SERVICE NOTICE 53

DN5000 Board Enhancements

Revised 11/16/03

MACHINE BOARD

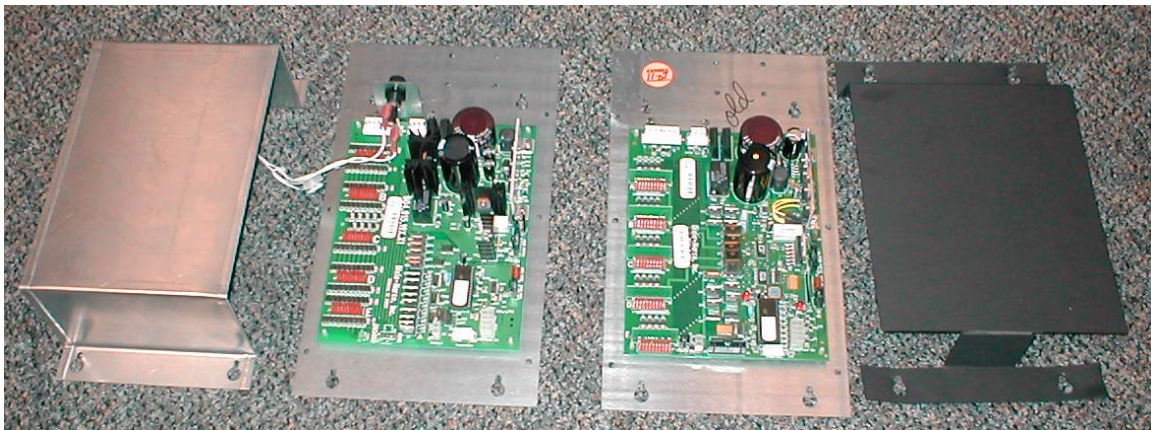
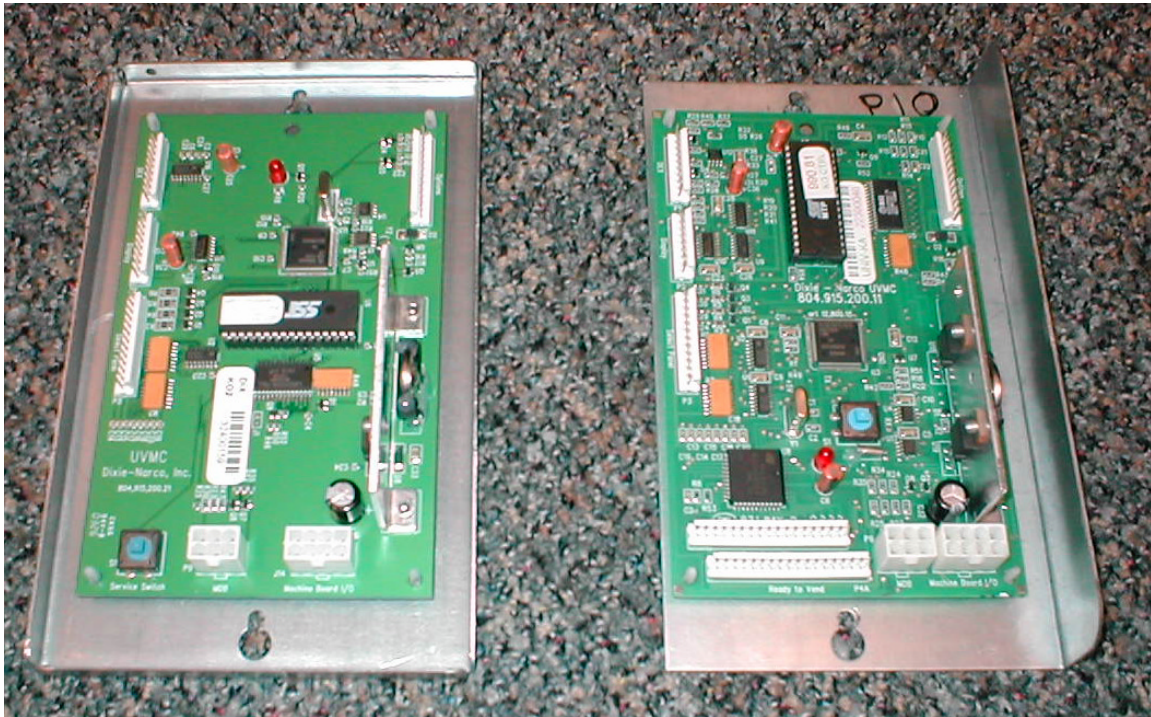
Enhancements were made to the following functions of the Machine Board: elevator motor driver, solenoid drive, regulated 24VDC supply, and environmental circuit.

NEW BOARD

OLD BOARD

NEW BOARD & COVER

OLD BOARD & COVER

NEW MACHINE BOARDS (factory installed 8272CB-0077 and higher)

Domestic/Japan Machine Board:	626,032,10x.x3 – New	To Be Determined – New reconditioned
Export Machine Board:	626,032,20x.x3 – New	To Be Determined – New reconditioned

Important: when using a New Machine Board the Universal (KO) software must be 804,918,991.01 or higher.

UNIVERSAL (KO) BOARD

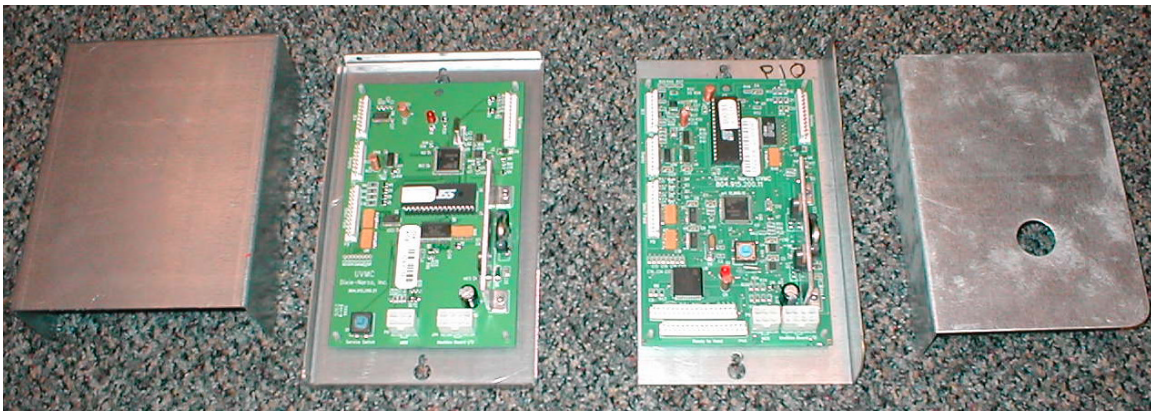
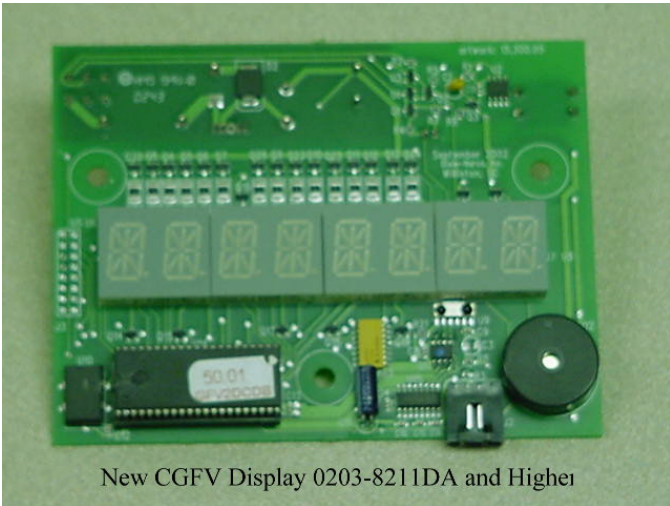
Enhancements were made to the following function of the Universal (KO) Board: radiated and conductive noise filtering, additional grounding to enhance sustaining memory.

NEW BOARD

OLD BOARD

NEW UNIVERSAL (KO) BOARDS (factory installed 8272CB-0077 and higher)

Universal (KO) Board T8: **626,056,30x.x4 – New** **495,061,24x.x3 – New reconditioned**
 Important: when using a New Machine Board the Universal (KO) software must be 804,918,991.01 or higher.

DISPLAY BOARD

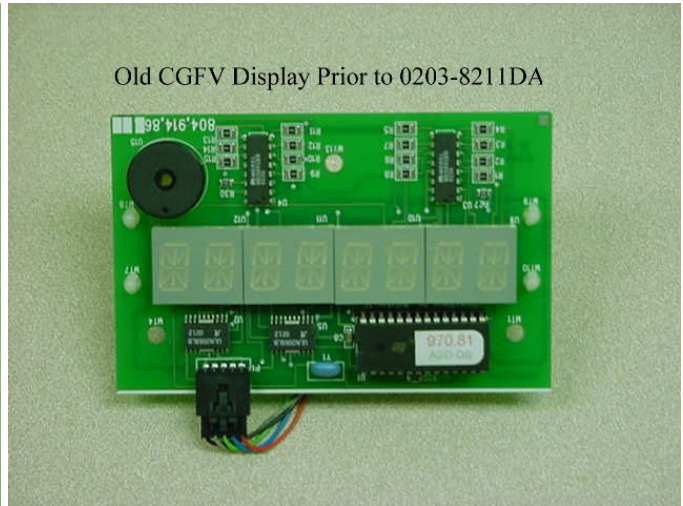
Enhancements were made to the following function of the Display Board: IR capable.

New CGFV Display 0203-8211DA and Higher

Old CGFV Display Prior to 0203-8211DA

NEW DISPLAY BOARD (factory installed 8211DA-0203 and higher)

Display Board: 804,919,93x.x1 – New
Software – 804,920,05x.x1

New Display is backward compatible but IR is not capable due to the Transaction Panels Display hole size.

IMPORTANT: Display software is not compatible between the two different Display Boards.
